Z O N I N G
A D J U S T M E N T S
B O A R D
S T A F F R E P O R T

FOR BOARD ACTION
OCTOBER 26, 2023

600 ADDISON STREET

Appeal of Design Review Committee Decision to approve the Coordinated Sign Program #DRCP2023-0002 for exterior building signage of an approved research and development (R&D) campus containing two buildings totaling 470,573 square feet of gross floor area and 943 parking spaces.

1 LOCATION PLAN
 Scale:NTS

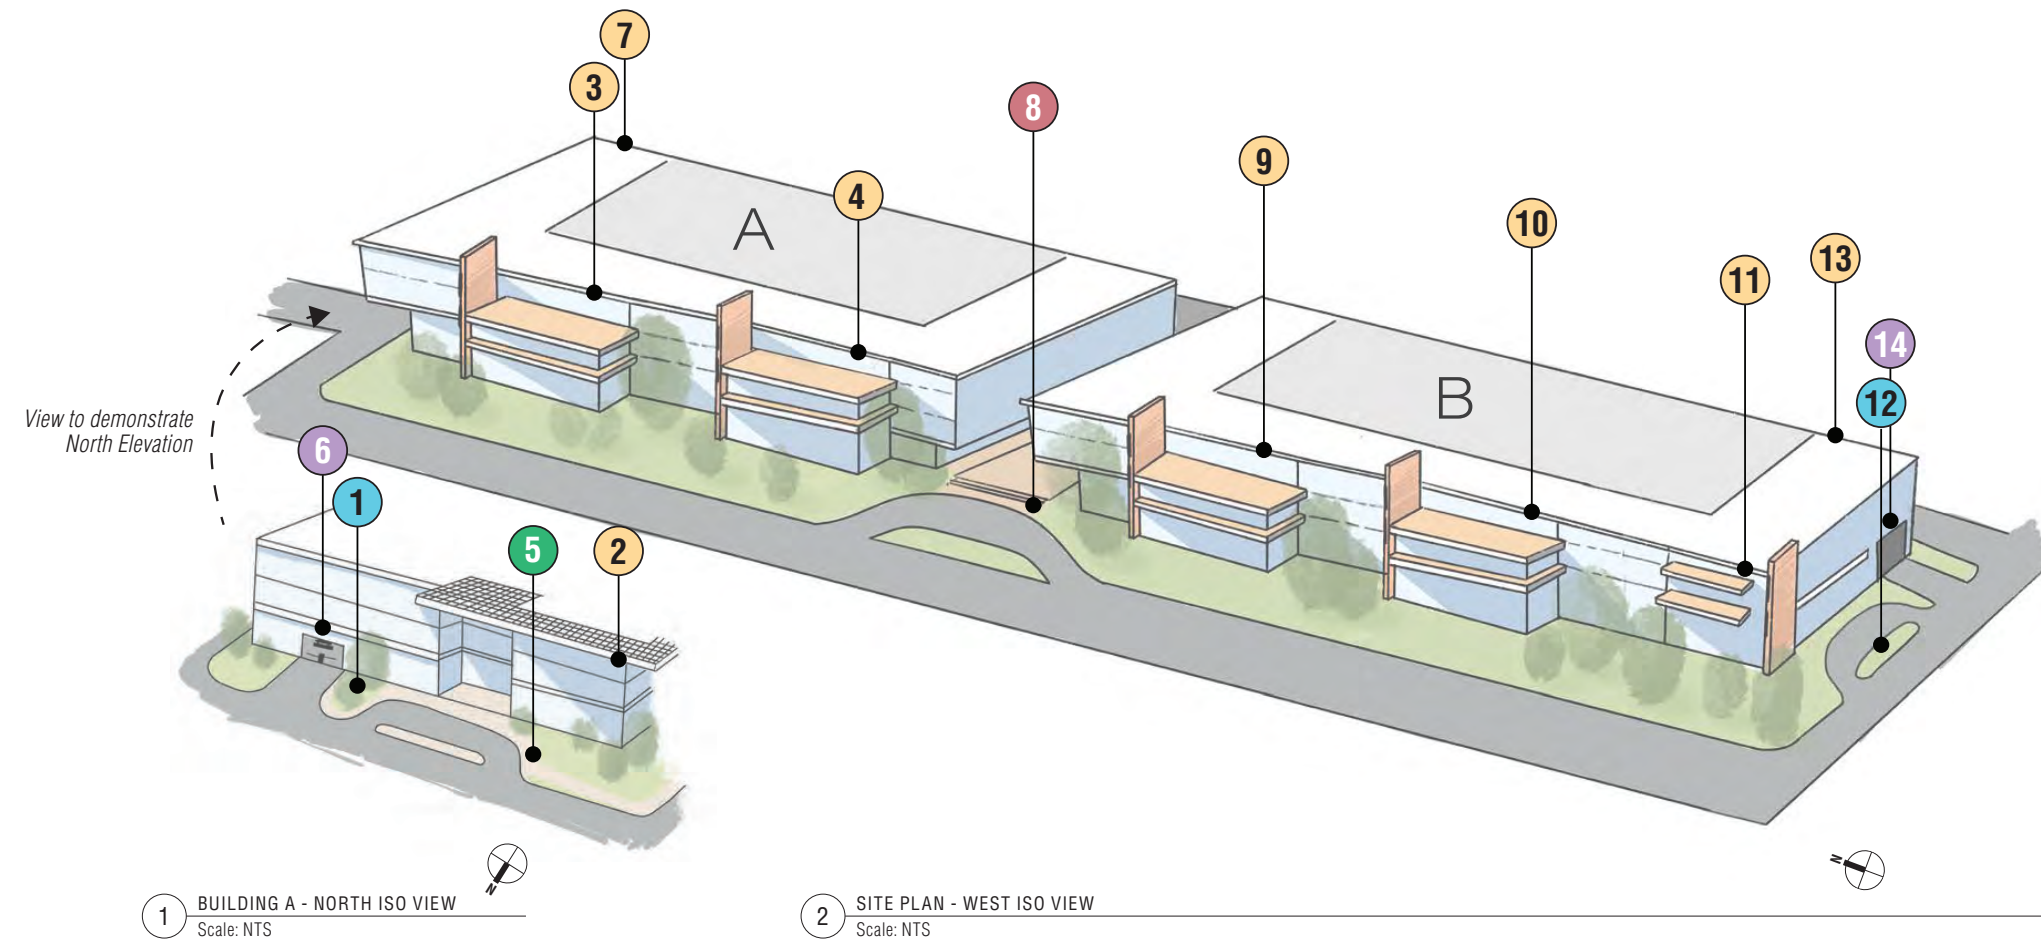
- B. Manufacturing District Regulations** (BMC Chapter 20.32): The number of total wall signs proposed exceeds the Ordinance. While only one wall sign for each street frontage is allowed in the Ordinance, the maximum size proposed for each wall sign is significantly less than the maximum 800 square feet and the total sign area for each parcel is significantly less than the maximum 2,000 square feet allowed for each parcel. Refer to Sheet 04 in the plan set.

- C. Number of signs exceed the total allowed for a project of this type in the Manufacturing District and also violates the City-wide ban on signage above a certain height:** The number of total wall signs proposed exceeds the Ordinance. While only one wall sign for each street frontage is allowed in the Ordinance, the maximum size proposed for each wall sign is significantly less than the maximum 800 square feet and the total sign area for each parcel is significantly less than the maximum 2,000 square feet allowed for each parcel. Refer to Sheet 04 in the plan set.

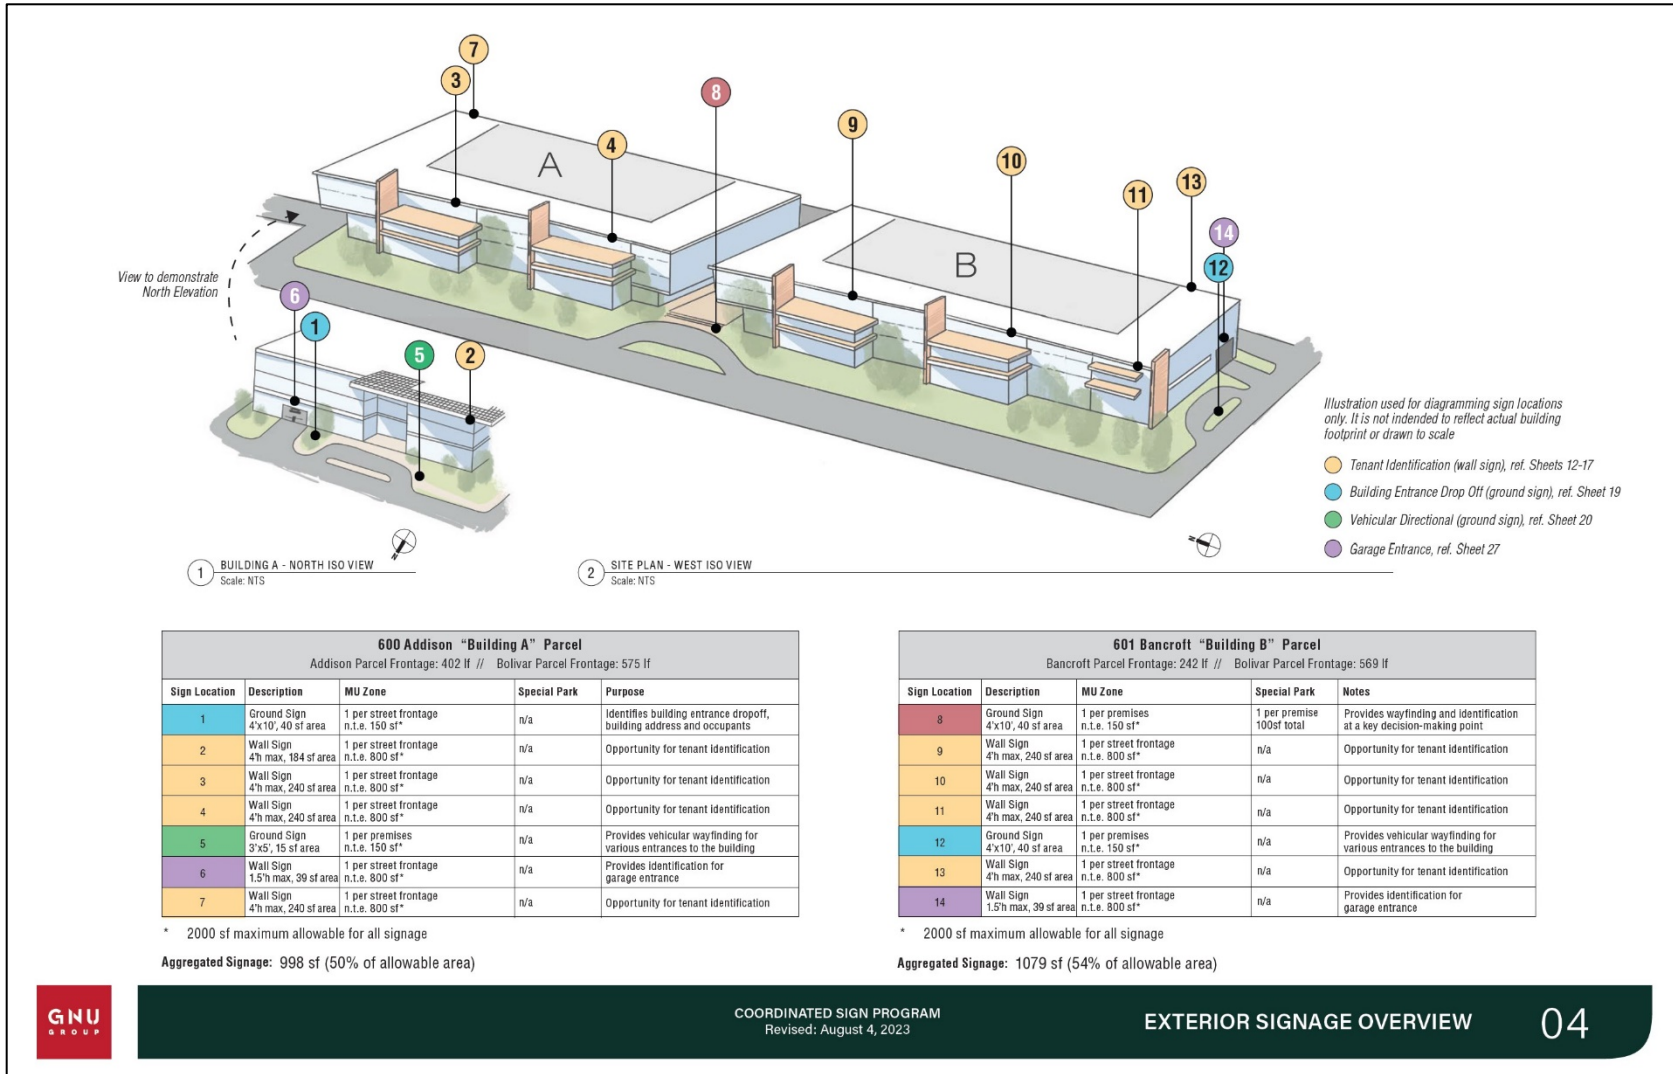
- 3) Because the approved signs will be located both under extended sun shades and above lower building projections (see Figure 1), direct light emanating from them will not be visible from above nor from below out to a distance encompassing the eastern margin of Aquatic Park, thereby having minimal potential for impacting birds that occupy the eastern shoreline of the park.
